REMARKS

AMENDMENTS TO THE DRAWINGS

Fig. 2

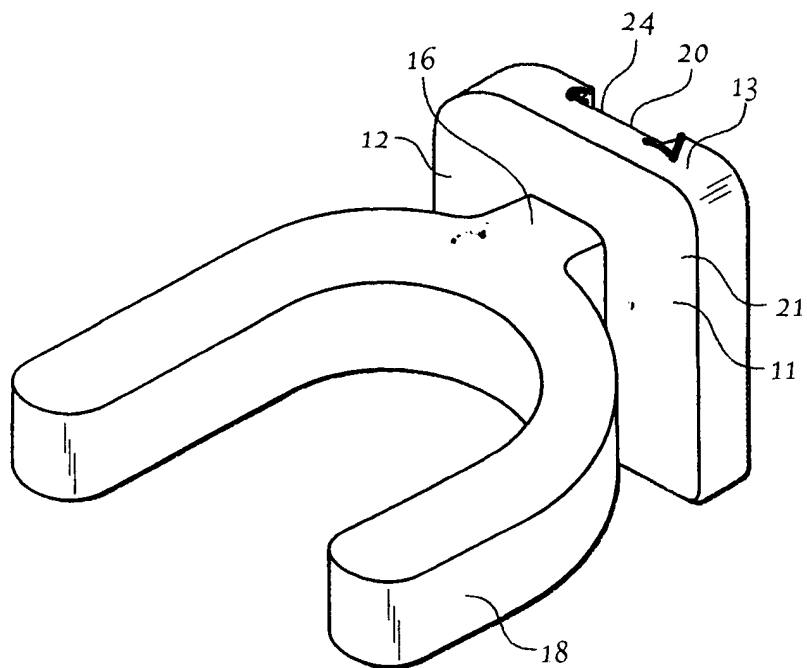
The drawings were objected to as failing to clearly show the cavity being wider at the bottom than at the top. Figures 2, 3, 4, and 5 were stated to appear to not be able to coact together. This amendment presents replacement sheets with amendments to Figures 2, 3, and 5 which clearly show the cavity being wider at the bottom than at the top, and show the sides of the support platform and of the cavity as undercut. The Figures as amended are able to coact together. Basis in the specification for these amendments is at Figures 4 and 6 and at page 6, lines 22-24; page 6, lines 26-27; and page 7, lines 17-19.

Fig. 3

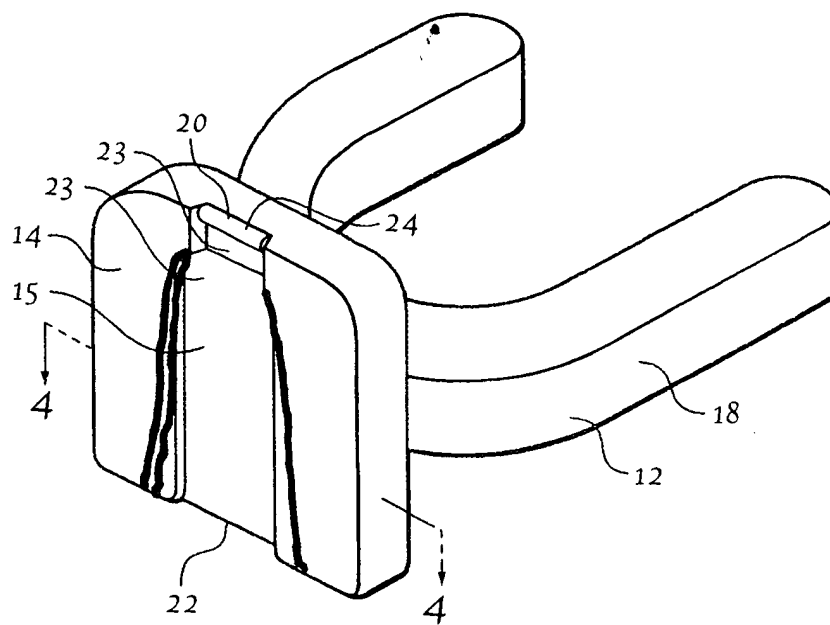
The Examiner stated that Figure 4 did not look consistent with Figures 2 and 3 because Figure 4 shows the sides of the cavity being parallel. Applicants respectfully suggest that Figure 4 is a cross-sectional view taken from Figure 3 and as such has no depth and, cannot show the sides of the cavity being parallel.

Fig. 5

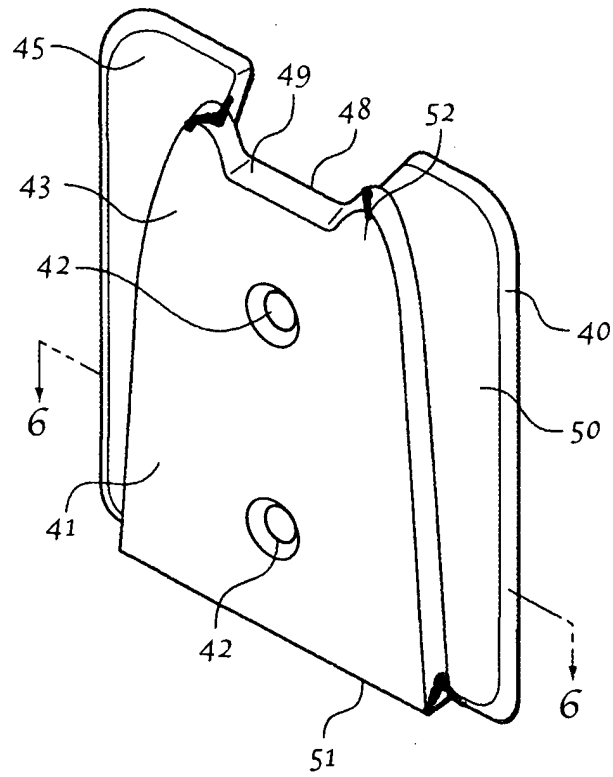
Claim 1 is currently amended to add the limitation that the platform on the support platform be of uniform thickness. Basis in the specification is found at Fig. 5 and Fig. 8.
